## TRANSMITTAL

COPIES	NUMBER	DESCRIPTION	CODE
1		FRP Fabrication NCR 7 - Pontoon 3 Dry Spots	H

**Brookfield BRF FLBR (2)**

Nonconformance

**Figure 1 – West End, Radius Side**

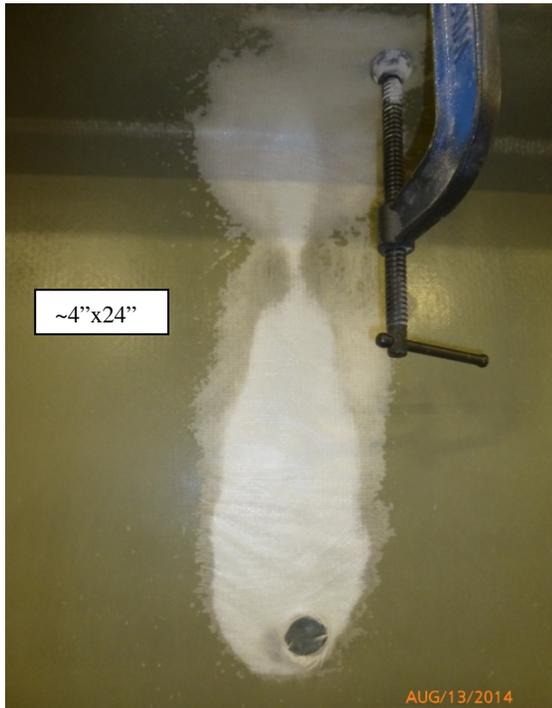
After de-molding the hull for Pontoon 3, Kenway discovered 4 areas of dry fabric on the exterior (mold side). These regions are shown in Figures 1 – 4.

Further evaluation of these areas reveals that the dry fabric is predominantly limited to the C-veil layer with minimal isolated dry fiber on the outer surface of the mat only on the 4008 layer. The one exception is the East End, Radius Side where the dry fabric in the flange extends through the thickness. These areas are perfect candidates for reinfusion.

1. Place a smooth caul plate (such as a sheet of HDPE) over the affected area having a series of small resin feed holes along the centerline of the dry area.
2. Place vacuum lines parallel to the line of feed holes on both sides of the caul.
3. Pull vacuum and establish the required drop test conditions.
4. Infuse the area, allow to cure, and inspect using visual and UT methods.

**Figure 3 – West End, Radius Side: Dry Fabric Depth**

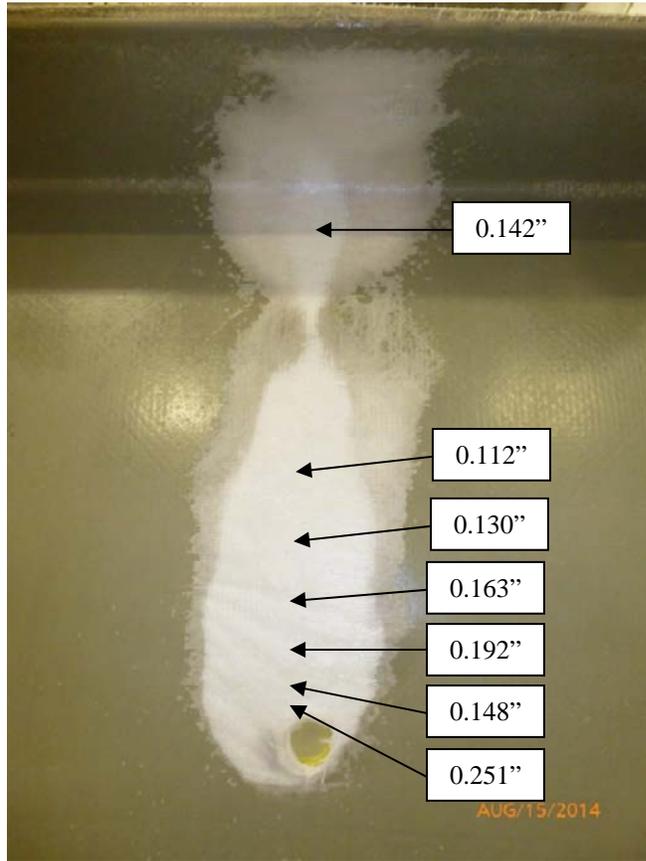
Table 1 lists the maximum and mean depth of dry fabric measured along a vertical centerline at each defect location and the corresponding minimum and mean thickness of solid laminate based on an average hull thickness of 0.607 in.

Based on the existence of continuous solid laminate throughout the entire length and width of the pontoon hull, the relative area and shallow depth of the dry regions, and the well documented use of re-infusion as a valid repair technique during fabrication of marine structures (as approved by ABS, the U.S. Navy, Ingalls Shipyard and Bath Iron Works), Kenway requests that Pontoon 3 be accepted once successful re-infusion of the dry areas has been performed and inspected.

**Figure 10 – ABS Through Thickness Damage Repair Example**

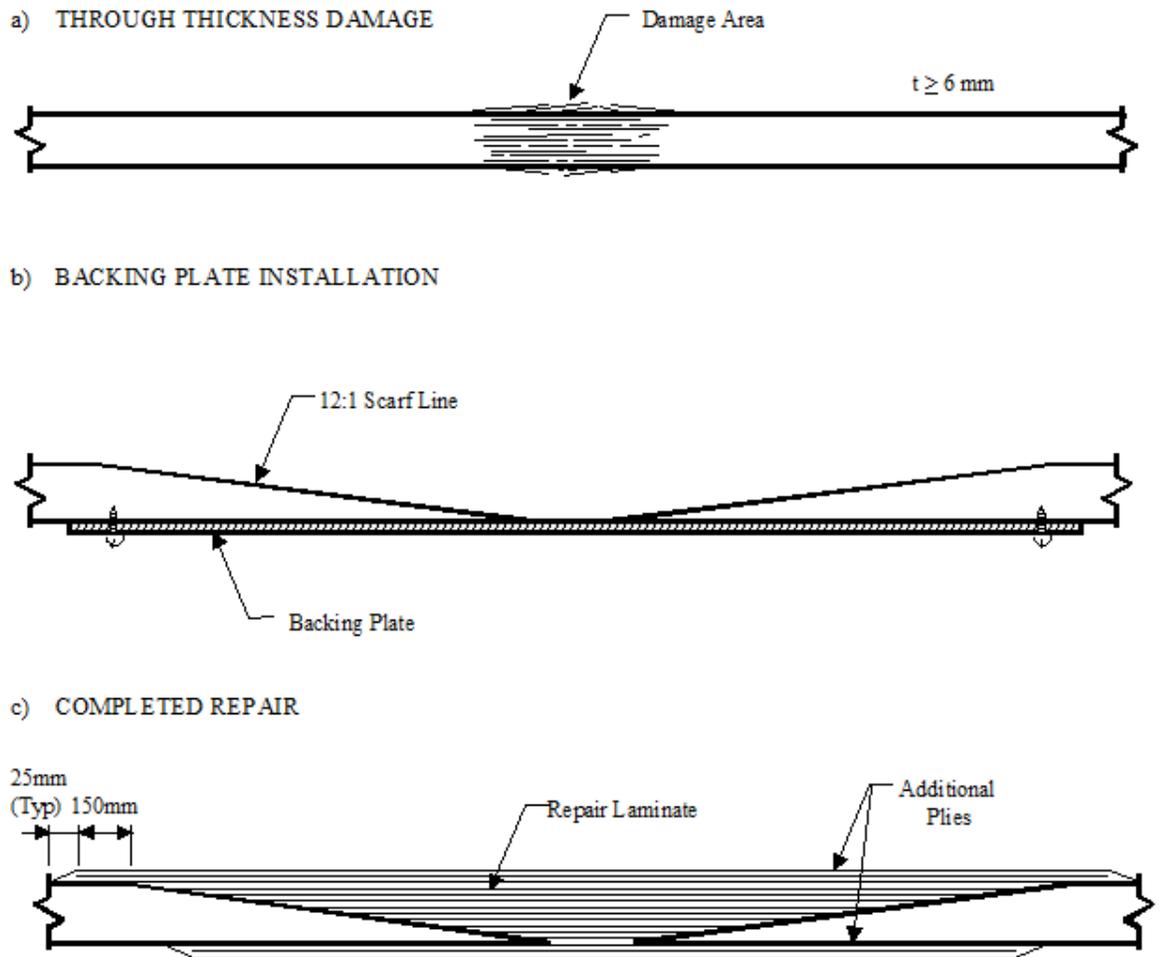
3. Both repair guides mentioned above, as well as the ABS Guide for Building and Classing High Speed Craft, also permit the repair of damaged areas allowing the removal of solid laminate through the entire thickness, the inclusion of a 12:1 taper, and subsequent hand lamination of a secondary laminate of equal thickness to the original infused laminate as shown in Figure 10.

- a. This is significant since the approved repair process on composite hull structure demonstrates confidence in watertight and structural integrity of primary ship structure when no continuous fiber exists across the joint and only a secondary resin bond exists.

- b. Local damage repair is specified with hand lamination, having higher resin content than infusion, which is why a few extra ply are shown in Figure 10.

- c. In the case of pontoon re-infusion, the same resin bond exists but there is also continuous fiber across the joint – similar to rebar ties in concrete slab construction joints.
